RE: Approval of Change Orders No. 6, 8, 10, 11, and 12

Seacrest Phase 1

City Project No.: 14-071

Change Proposal Request	
CPR #	010
Issue Date	12-Apr-2018
Subject	Seacrest intersections
Revised:	02-May-2018

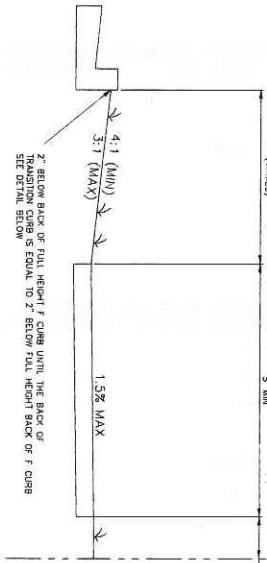
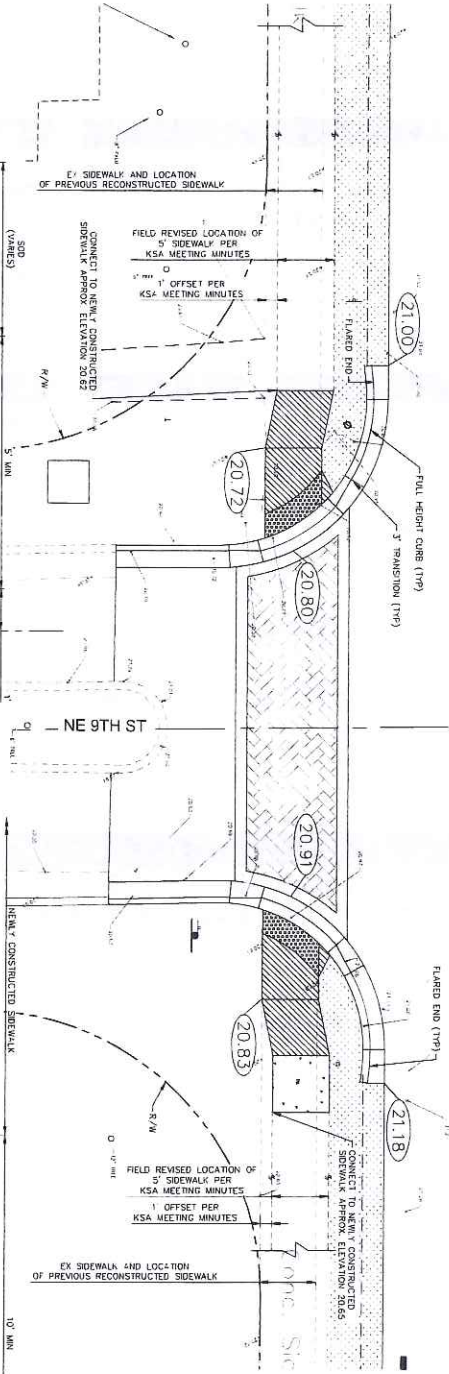
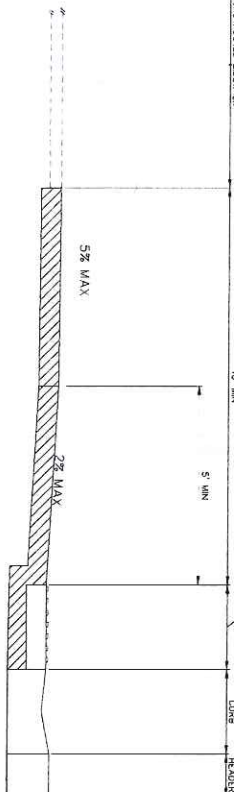
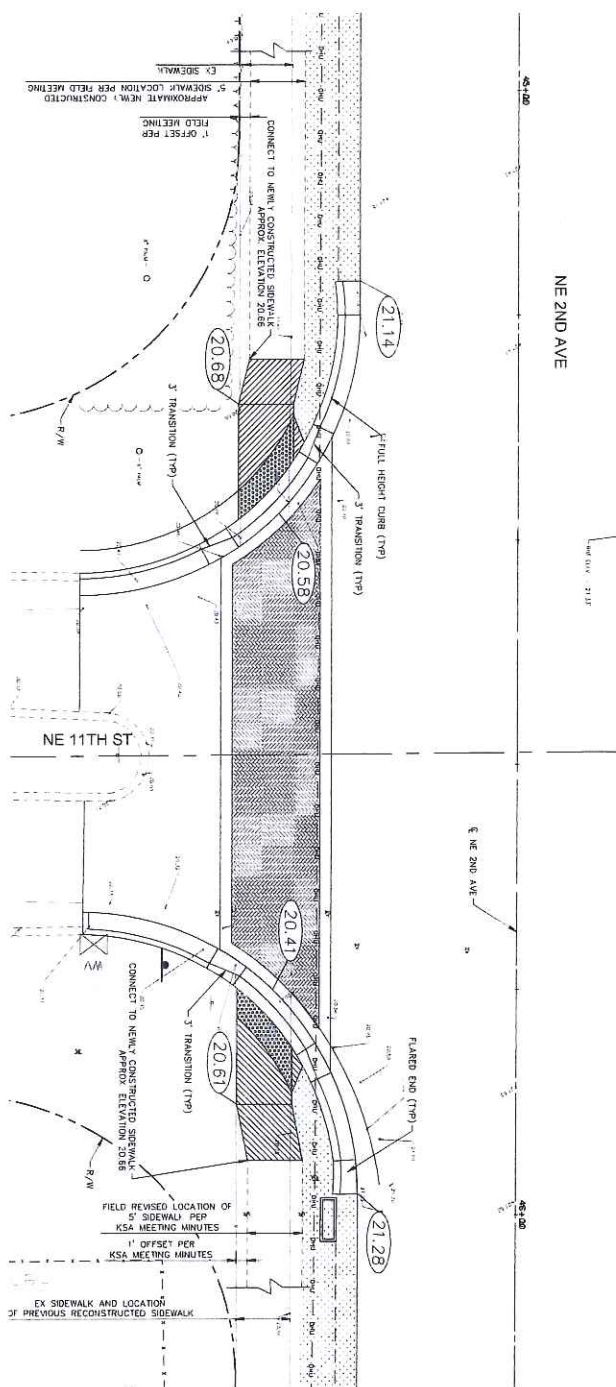
3ft. transition at the ramp per detail on sheet C-11 or 6ft. per FDOT index 304. Please Clarify.

Response
Please use the 3' transition. At George Bush ADA Ramp (South End of the project & NW corner) West need to comply with FDOT Index # 304 having 6' transition at one or both side of the ramp. Please follow the curb return revision/detail.

SHEET:
D-1

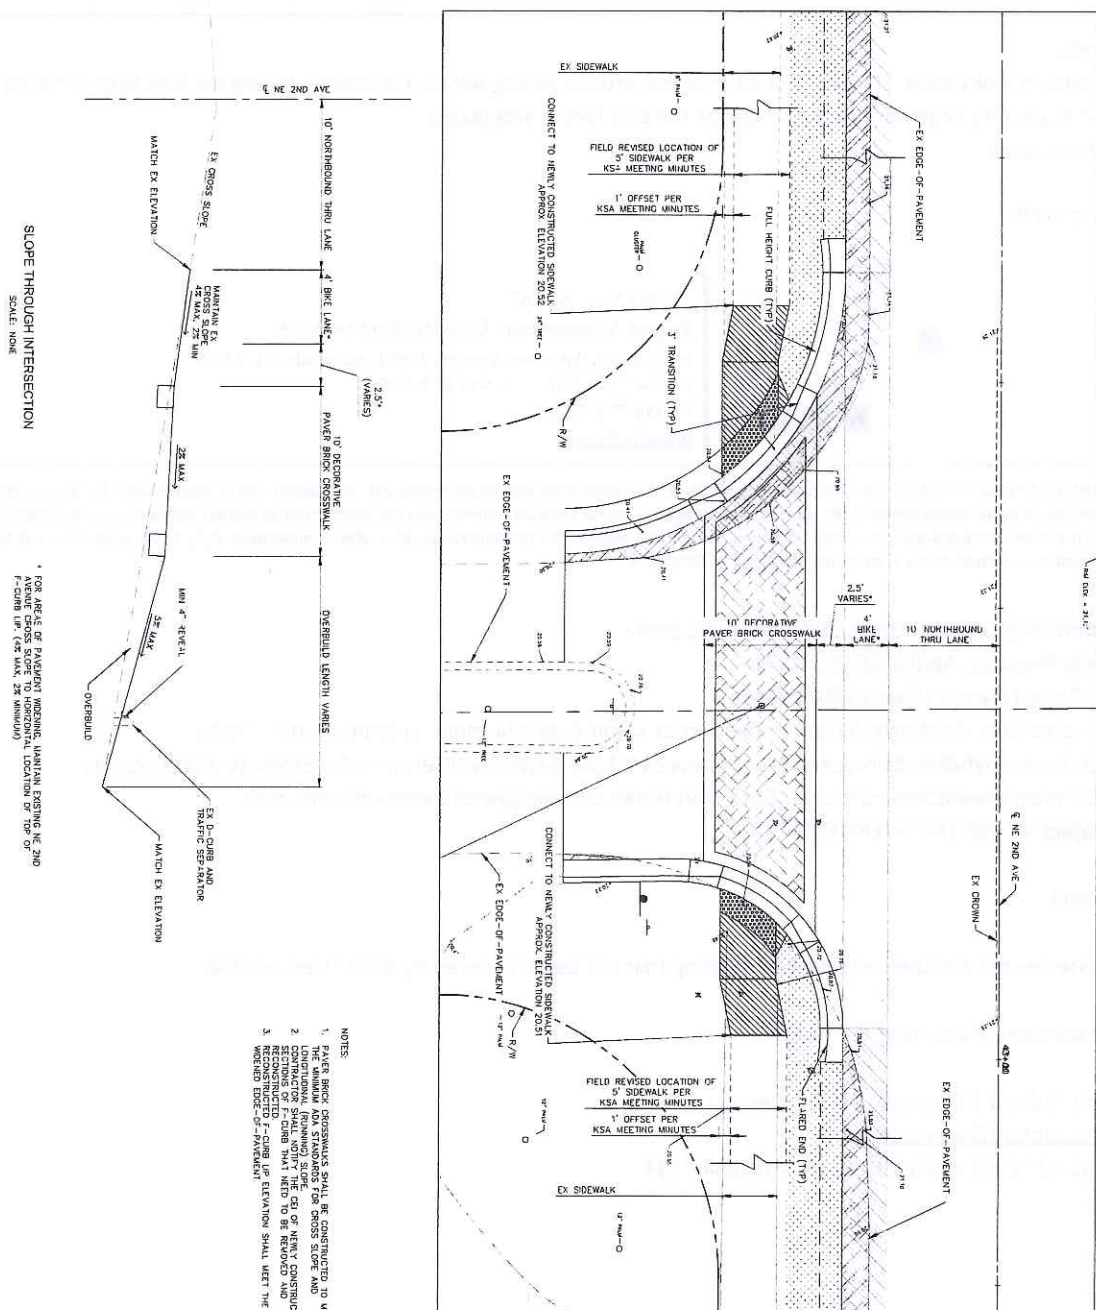
The existing cross slope at the intersections of 11th, 13th, 12th, NE 2nd Ave and the south half of 10th St. exceed the allowed 2%. Curbs have been poured at the most recent elevations. As is the cross walk will not meet ADA requirements. **Please advise.**

Response
Per WGI direction. This detail can be applied to all intersections on the east side of NE 2nd Avenue. For visualization, the plan view will remain the same as in the plans, but the section view (south of the intersection looking north, or north of the intersection looking south) will reflect the section in the detail.
